COMMONWEALTH OF KENTUCKY
BEFORE THE PUBLIC SERVICE COMMISSION

CENTER RIDGE WATER DISTRICT, INC.)	
<hr style="width:50%; margin-left:0"/>)	CASE NO. 2008-00145
)	
ALLEGED VIOLATIONS OF 807 KAR 5:066)

ORDER

UTILITY INSPECTION REPORT

Loose wiring in the # 1 wellhouse

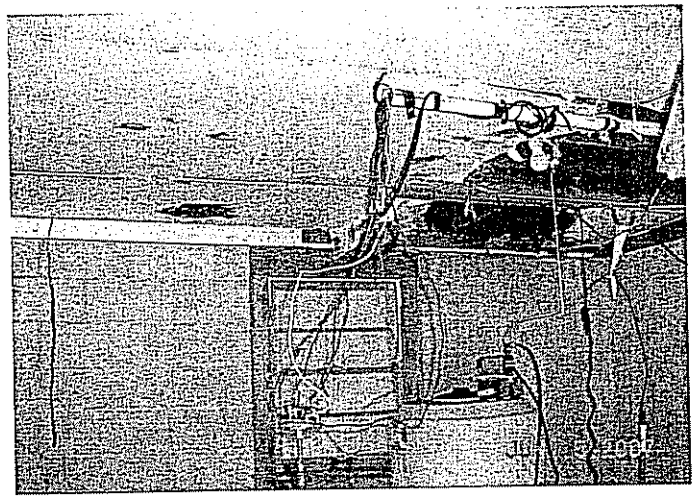
All 4 water systems appears to be in need of maintenance. Loose wiring is present in all 4 systems, and the #3 system has a leaking and rusting water tank. The main concern is the reason these facilities were allowed to reach their current condition. This is indicative that the utility's facilities are not operated with adequate and safe service to its customers. This could also be indicative of the utility's lack of adherence to prescribed inspection/maintenance procedures or operation and maintenance manual.

Center Ridge Water District shall provide maintenance attention to all 4 water systems. Loose wiring is present in all 4 systems and shall be enclosed in a conduit to prevent electrocution. Also, the tank in system #3 is leaking and rusting. These maintenance recommendations should be the result of the utility's adherence to inspection/maintenance procedures filed at the Public Service Commission.

3 system with a leaking and rusty water storage facility (1000 gal.)

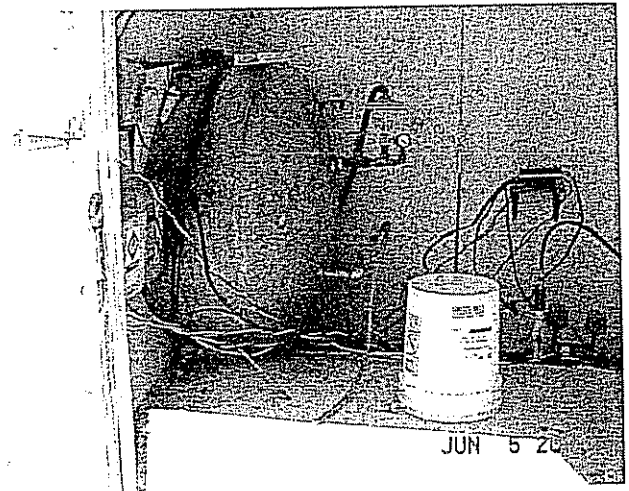
3. As it has allowed the water storage tank serving Center Ridge System No. 3 to rust and develop leaks, Center Ridge has failed to operate and maintain Center Ridge System No. 3's distribution system in a manner to provide adequate and safe service to its customers as 807 KAR 5:066, Section 7, requires.⁴
